MFN 06-262
Supplement 4

Subject: **Modified Reactor Building/Fuel Building Truncated Model,
SER-ESB-038 Rev. 5**

**Shimizu Engineering Report SER-ESB-038, Rev. 5,
“Modified RBFB Truncated FE Model Analysis Data,”**

Project	General Electric Company ESBWR Project	Shimizu Document No.	SER-ESB-038
Title	Modified RBFB Truncated FE Model Analysis Data	Rev.	5
		Issued Date	9/22/06
		Revised Date	1/9/07

Figure C-23 Element Forces Comparison NASTRAN to ANSYS (RCCV: Out-of-plane Shear [MN/m])

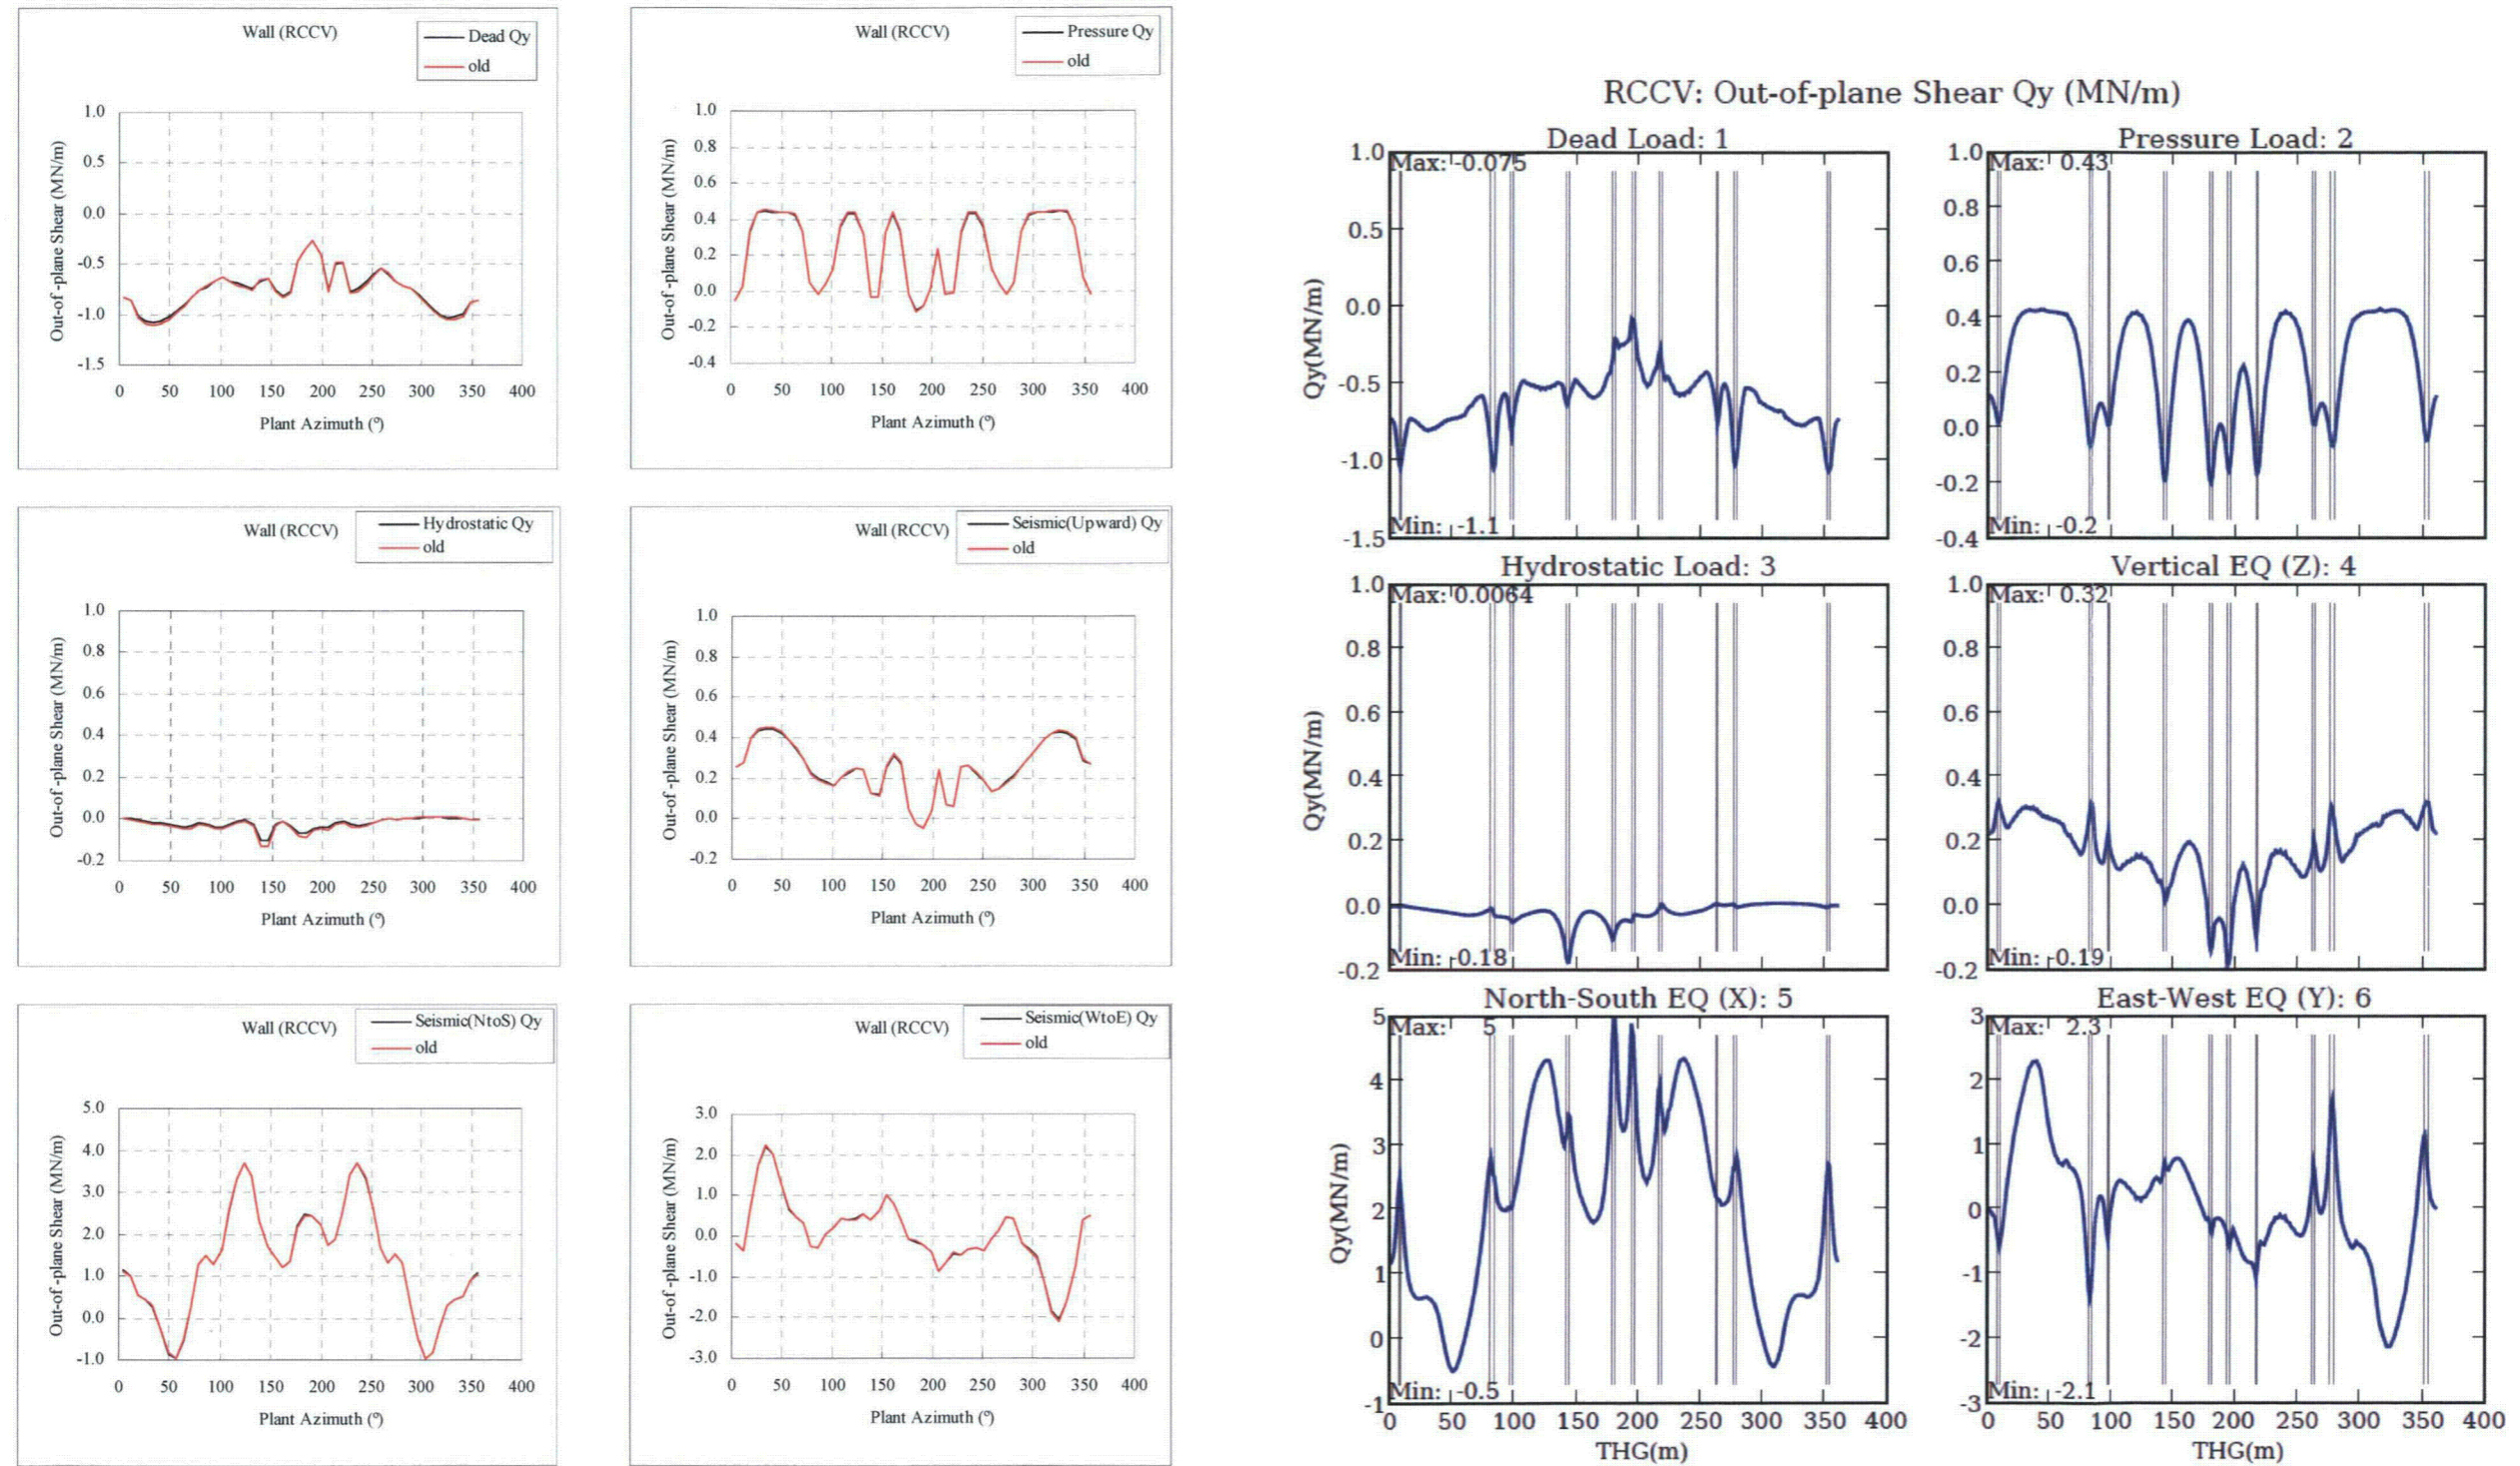
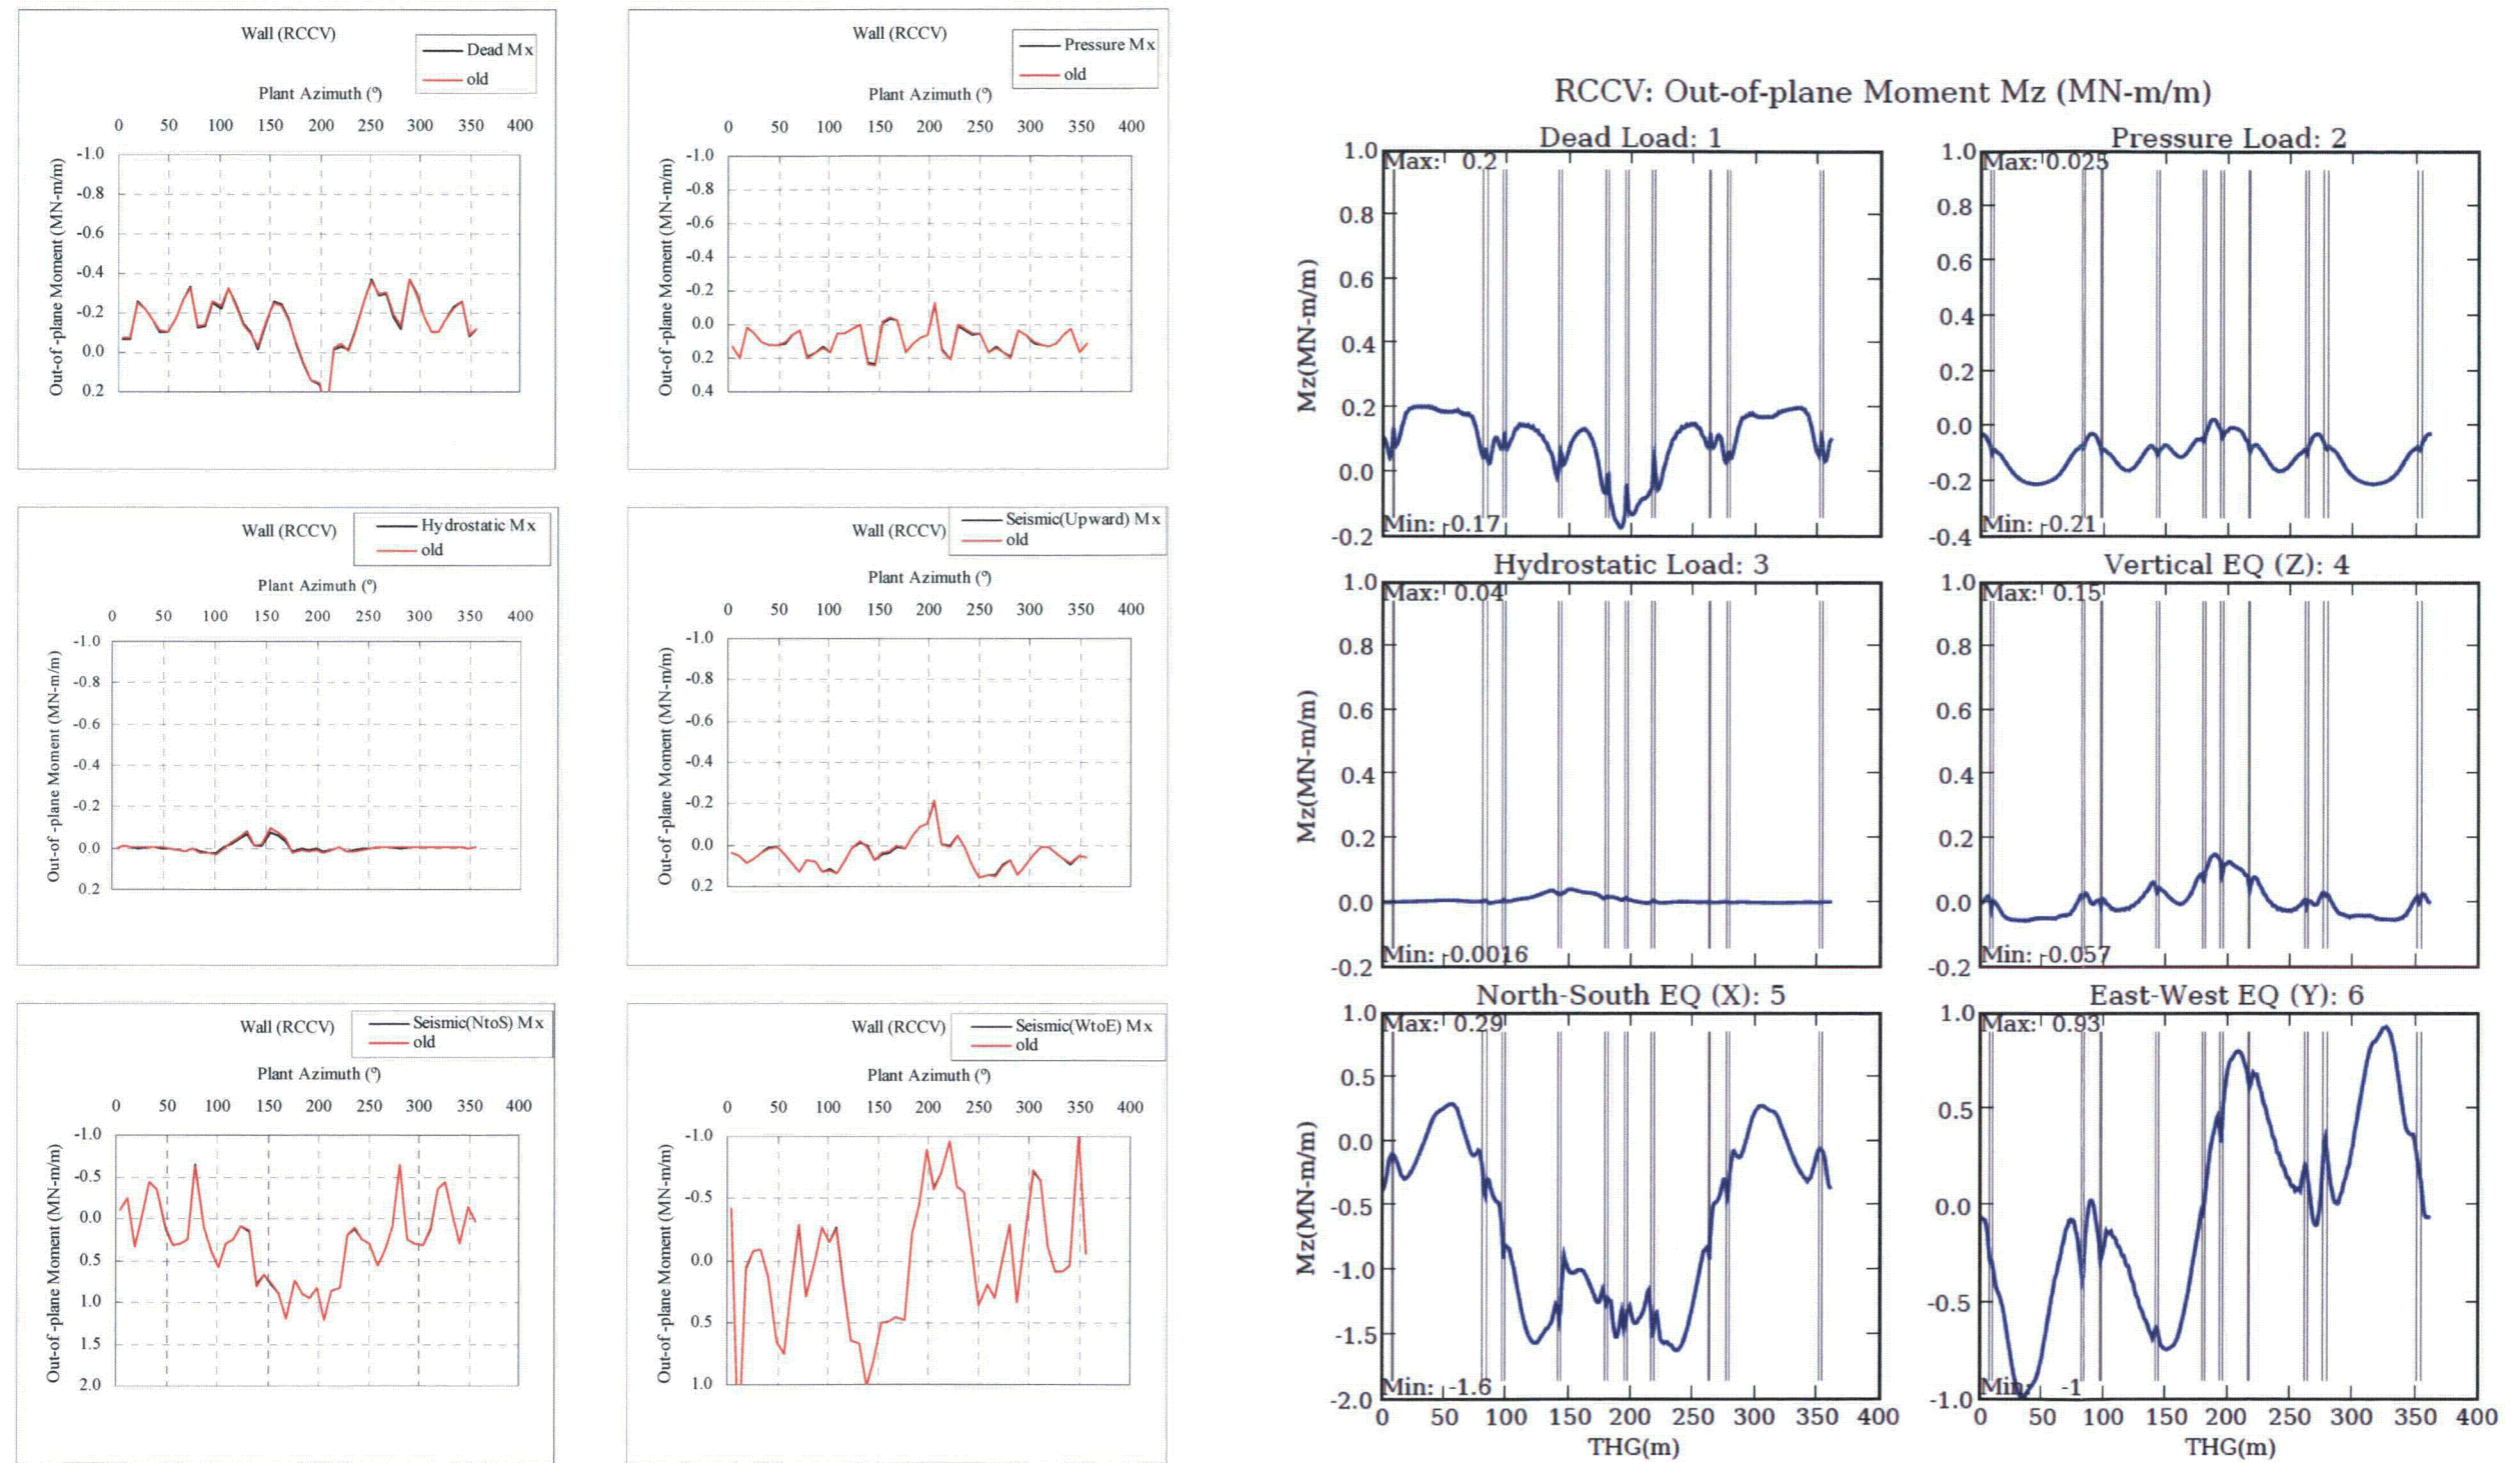
- iii) *The differences of magnitude of forces appeared on basemat inside pedestal:* The result of re-analysis using the updated model shows better agreement. In case of seismic load the magnitude of forces has to be re-compared because BNL's soil spring may not be adequate as pointed out above 3).

- iv) *The differences of magnitude of forces appeared on outer wall of Fuel Storage Pool (FSP):* For the out-of-plane shear forces and moments on RA and F3 wall located around FSP in case of Hydrostatic load, BNL's results are lower than those of GE. GE assumes the some part of differences comes from the difference of estimation levels between both models as pointed out above 8). In order to have a better understanding of the differences, GE would like to request BNL to confirm the input data for Hydrostatic load.
